COUNTY SANITATION DISTRICTS OF LOS ANGELES COUNTY

July 10, 2017
File No. 31-370.40.4A

**Comments on the Proposed 2016 Los Angeles Region
Clean Water Act Section 303(d) List of Impaired Waters**

Figure 1. CSCI Reference Density Cloud (Santa Clara River Sites within Black Circle).

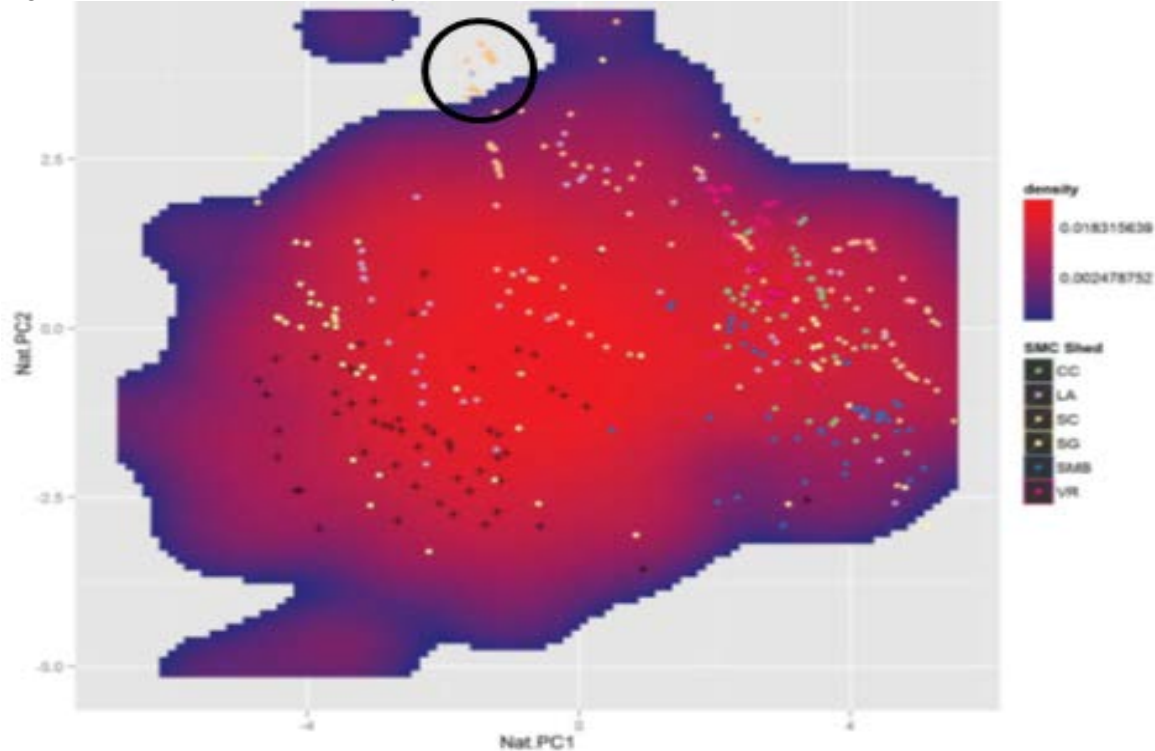
In response to written comments, the Regional Board stated, “The text accompanying the Reference Density Cloud in the presentation states, “*Could be used to establish exceptions for truly unique environmental settings.*” Nonetheless, it does not appear that any “truly unique environmental settings” have been established or are recognized by the State Bioassessment workgroup or other authority.” The Sanitation Districts acknowledge that there has been no formal designation of “truly unique environmental settings”. However, analyses suggest that a pronounced lack of reference sites in large watershed, low gradient, and low elevation systems still limits the identification of appropriate thresholds using the CSCI and casts a high degree of uncertainty on using the proposed 0.79 threshold.

Figure 1. CSCI Reference Density Cloud (Santa Clara River Sites within Black Circle).

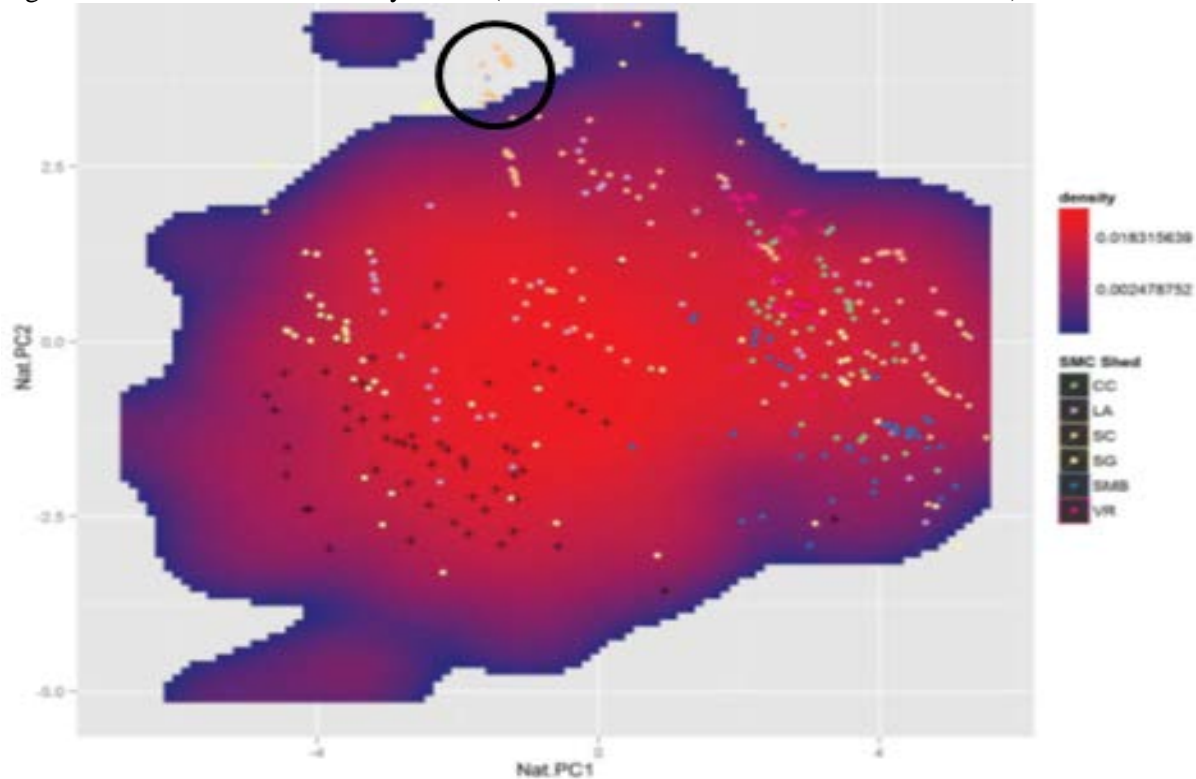
In response to written comments, the Regional Board stated, “The text accompanying the Reference Density Cloud in the presentation states, “*Could be used to establish exceptions for truly unique environmental settings.*” Nonetheless, it does not appear that any “truly unique environmental settings” have been established or are recognized by the State Bioassessment workgroup or other authority.” The Sanitation Districts acknowledge that there has been no formal designation of “truly unique environmental settings”. However, analyses suggest that a pronounced lack of reference sites in large watershed, low gradient, and low elevation systems still limits the identification of appropriate thresholds using the CSCI and casts a high degree of uncertainty on using the proposed 0.79 threshold.

Figure 2. Santa Clara River Reach 6, Classified as “Likely Constrained”

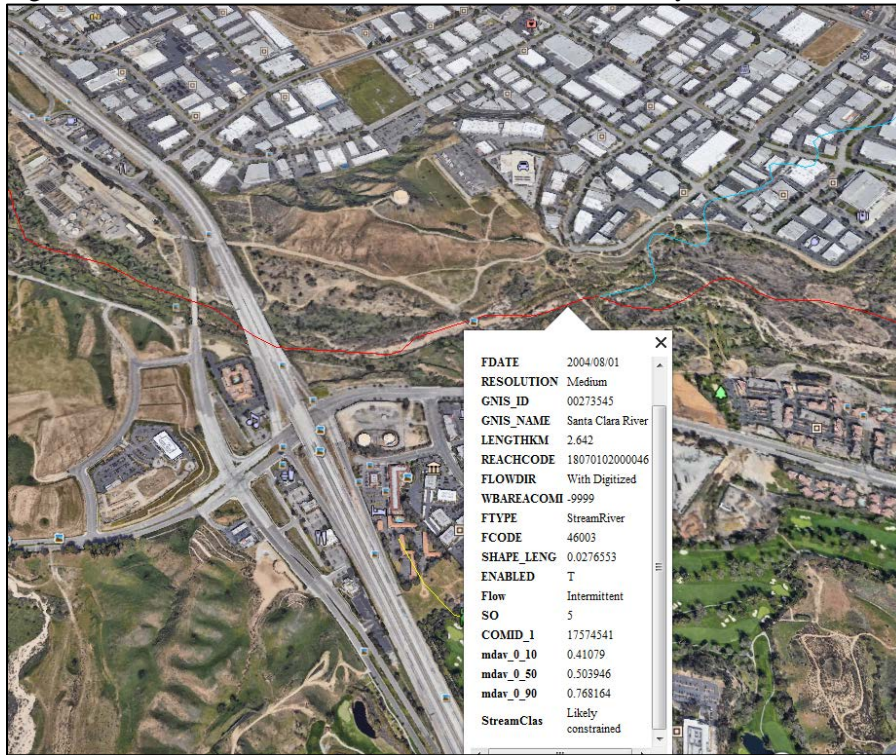
While there is no simple physical habitat that can be used for this evaluation, multiple other approaches are available. For example, the San Diego Regional Board’s (Region 9) most recent Integrated Report evaluated instream physical habitat data, CRAM data, and aerial imagery to evaluate habitat modification/hydromodification. A more recent tool developed by Southern California Coastal Water Research Project (SCCWRP) staff through a State Board effort has resulted in a quantitative tool to identify streams/reaches that are likely to be “constrained” by habitat or other, non-water quality parameters (the model used land cover, road density, canal density, mines, dams, aerial deposition, and non-native vegetation). When applying this tool to the Santa Clara Reach 6 location, SCCWRP determined that this location is “likely constrained”, meaning unlikely to achieve a CSCI score of 0.79 due to landscape development (Figure 2).

Figure 1. Pomona/San Jose Creek Receiving Water Map

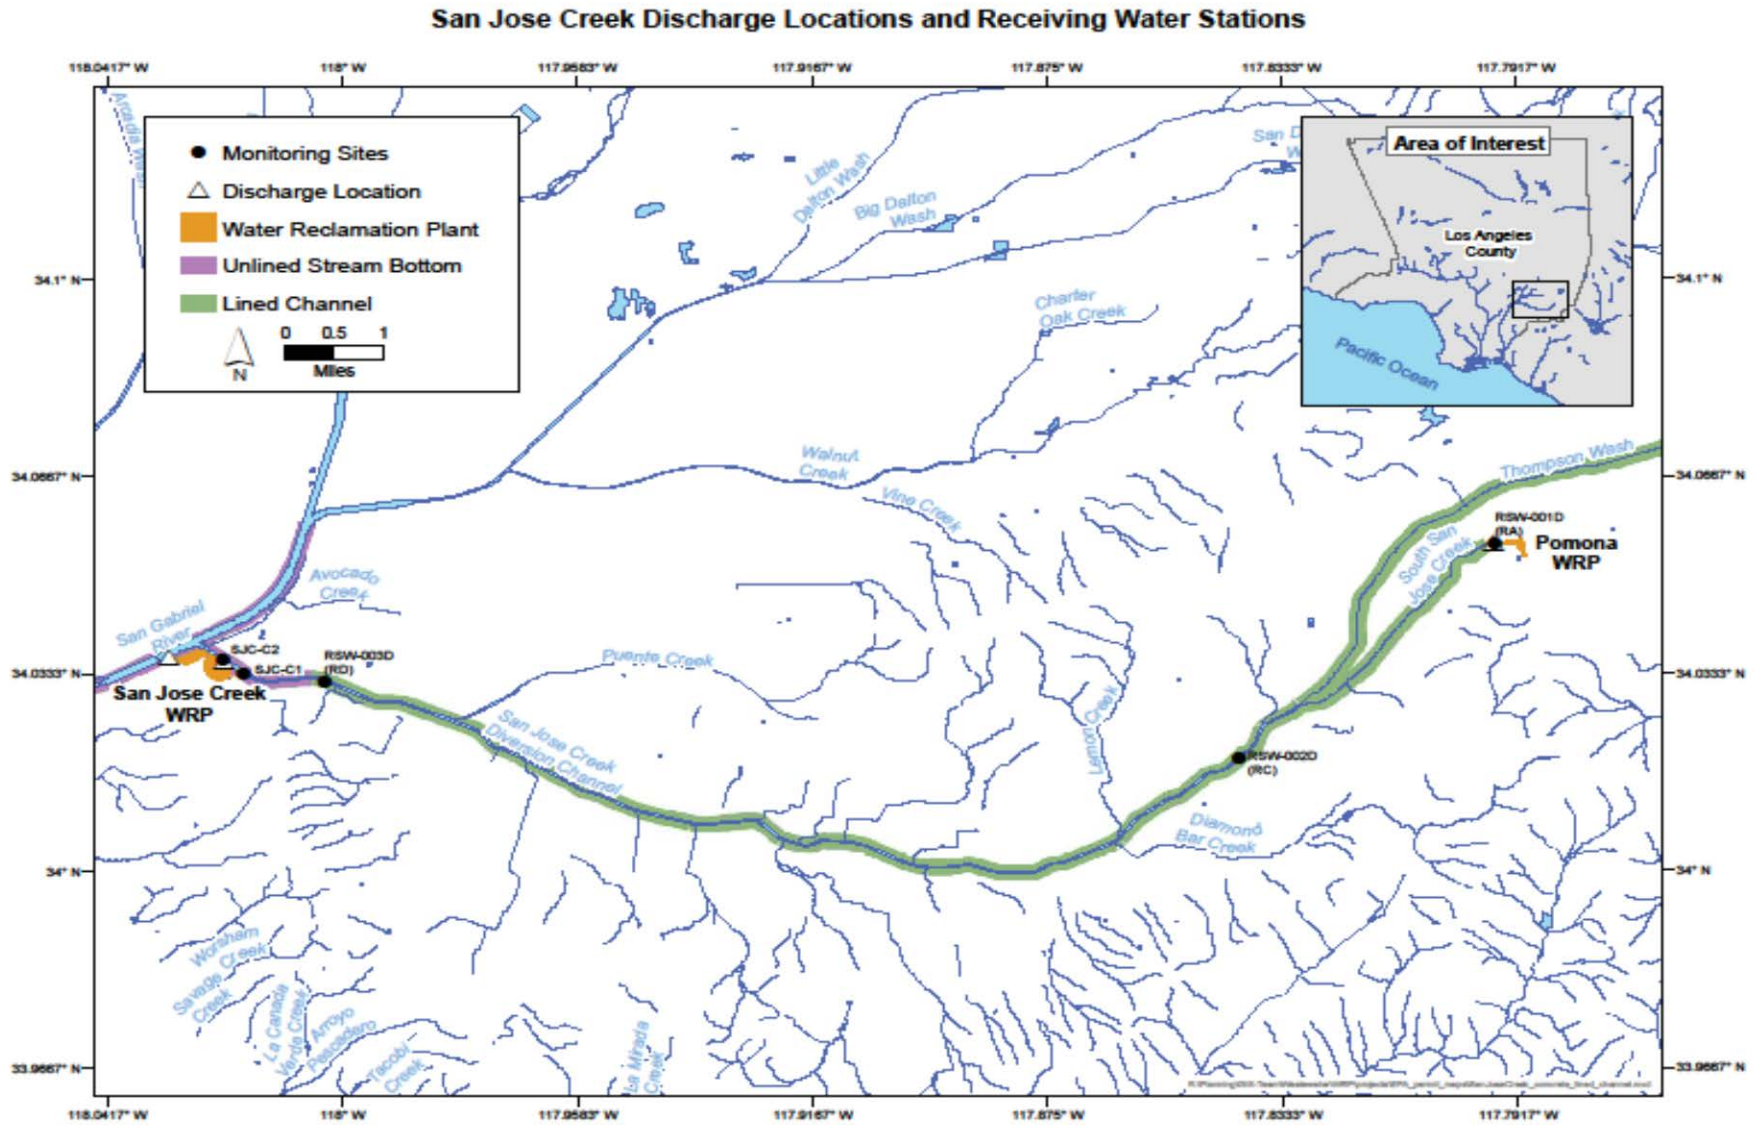
Tertiary treated water from the Pomona Water Reclamation Plant is discharged to the south fork of San Jose Creek and flows into Reach 1. Receiving water stations Pom-RC, Pom-RD, and SJC-C1 are located approximately 3, 12, and 12.5 miles from the upstream border of Reach 1, respectively. Reach 1 is fully lined in concrete from the upstream border to just upstream of SJC-C1 (Figure 1).

Figure 3. Measured Flow at Pom-RC and Pom-RD in the Absence of Discharge from Pomona WRP

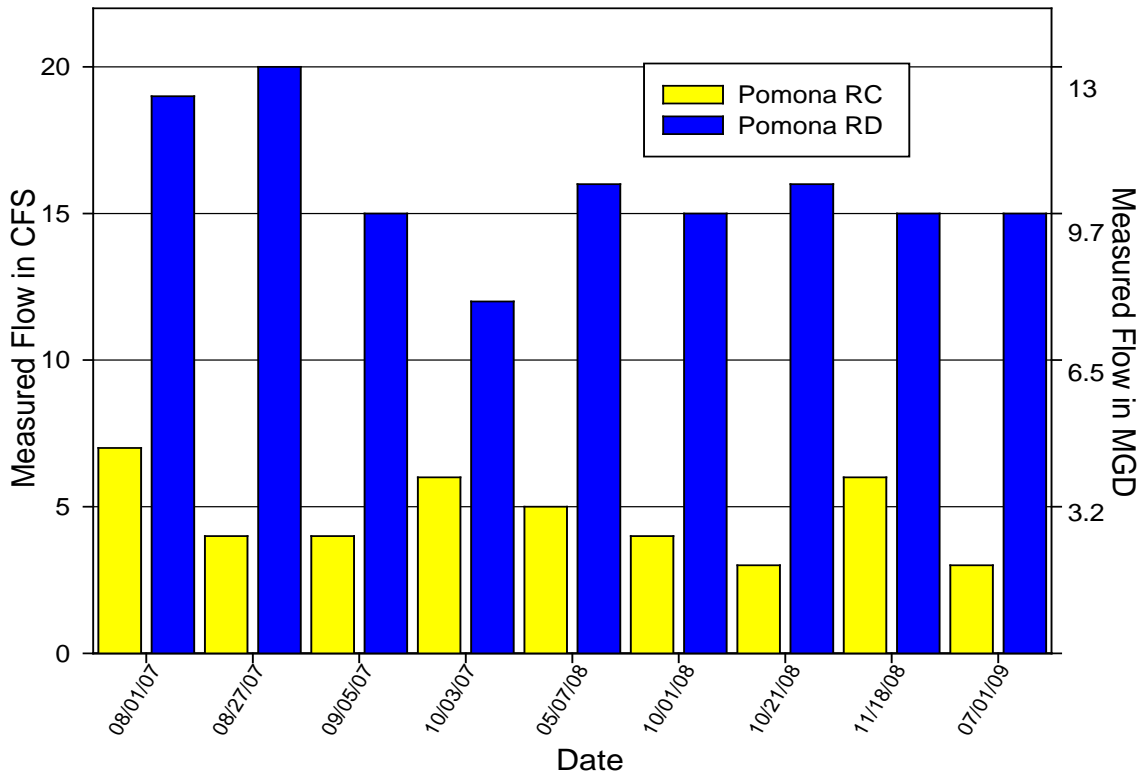
As observed by Sanitation Districts staff and corroborated by EPA staff¹, groundwater exudes from relief structures distributed throughout the concrete-lined bottom, even in mid-summer (August) after several years of drought (Figure 2). In the absence of discharge from the Pomona Water Reclamation Plant or other observed discharges, flows in SJC between Pom-RC and Pom-RD increase by 200% to greater than 400% (Figure 3) due to the release of this groundwater, which has a localized average temperature of approximately 67 °F.² As this groundwater-dominated flow travels downstream, the temperature naturally rises (Figure 4) due to heat conduction through the warm concrete lining and solar radiation exposure in the unshaded channel (Figure 5 shows ambient air temperature as a proxy for solar radiation³). When the concrete channel ends upstream of SJC-C1, the water leaves the heat source (concrete channel) and mixes with additional groundwater, resulting in consistently cooler temperatures. The observed spatial and temporal temperature profile, coupled with no identifiable waste discharges and substantial groundwater contributions, clearly demonstrates that the temperature excursions in Reach 1 of San Jose Creek are not a result of waste discharges.

Figure 5. 30-Year Normal Monthly Maximum Air Temperature at Pom-RD³

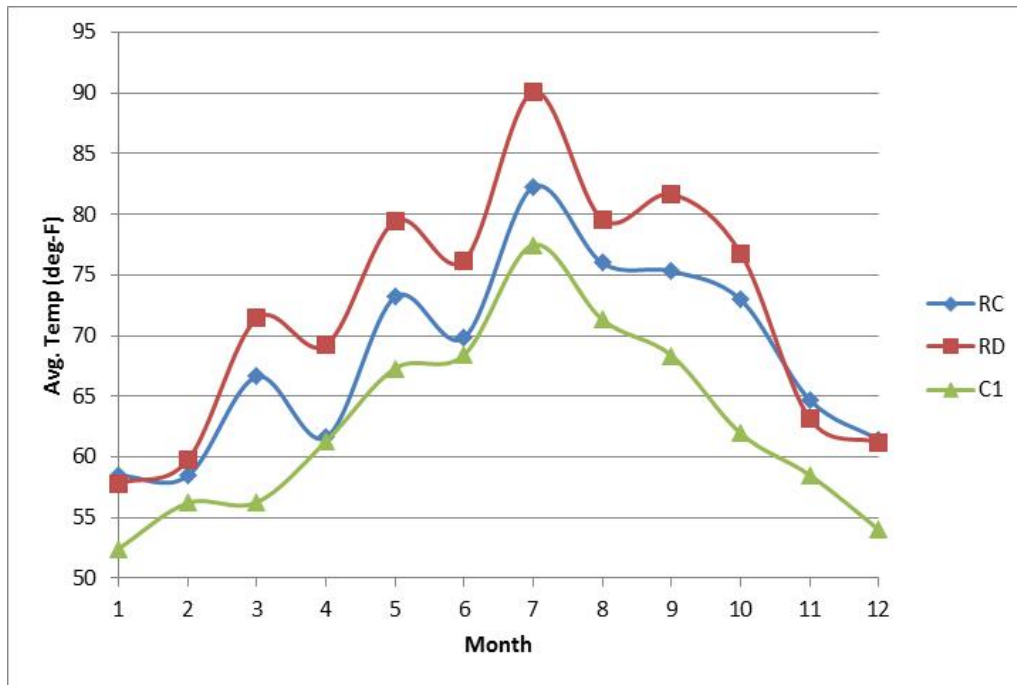
Therefore, when assessing the temperature objective in Region 4, an analysis of the source or cause is both required and critical in determining if the objective was exceeded. Furthermore, as described in more detail below, a Sanitation Districts survey clearly demonstrates that summertime excursions greater than the 80°F in this reach are not caused by waste discharges but are due to elevated ambient air temperature, conductive and radiative heating associated with hardened landscapes, a lack of riparian cover, and increased ambient temperatures related to climate change. Additionally, the proposed listing and associated fact sheets do not contain any analysis or evidence refuting the findings of this survey.

Figure 3. San Gabriel Reach 2 – Site R12

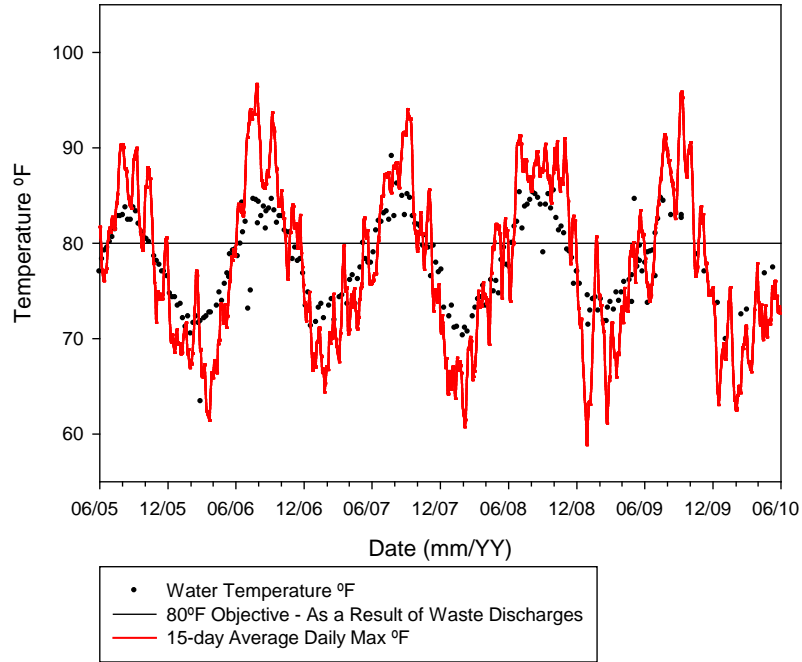
Tertiary treated water from the San Jose Creek Water Reclamation Plant (WRP) is discharged to the main stem of the San Gabriel River. The lower ¼ mile of Reach 2 is a fully lined concrete channel, containing the R2 receiving water station. Data from this station represent 215 of 232 data points. As explained in Fact Sheet #4, elevated temperatures in Reach 1 of San Jose Creek occurred even in the absence of observable waste discharges and were caused by conductive heating through the concrete lining and solar radiation exposure (Figure 4)². Although a comprehensive assessment of flows, in the absence of WRP discharge, cannot be conducted along the San Gabriel River, the same conditions associated with the radiative and conductive heating exist in this part of San Gabriel River Reach 2. This is further supported by the fact that 99% of excursions above 80 °F in the receiving water environment occurred during the warmer months, June through October. The weight of evidence supports the contention that receiving water temperatures above 80 °F were a result of ambient and environmental conditions (i.e., summer weather and a concrete channel) and not waste discharges.
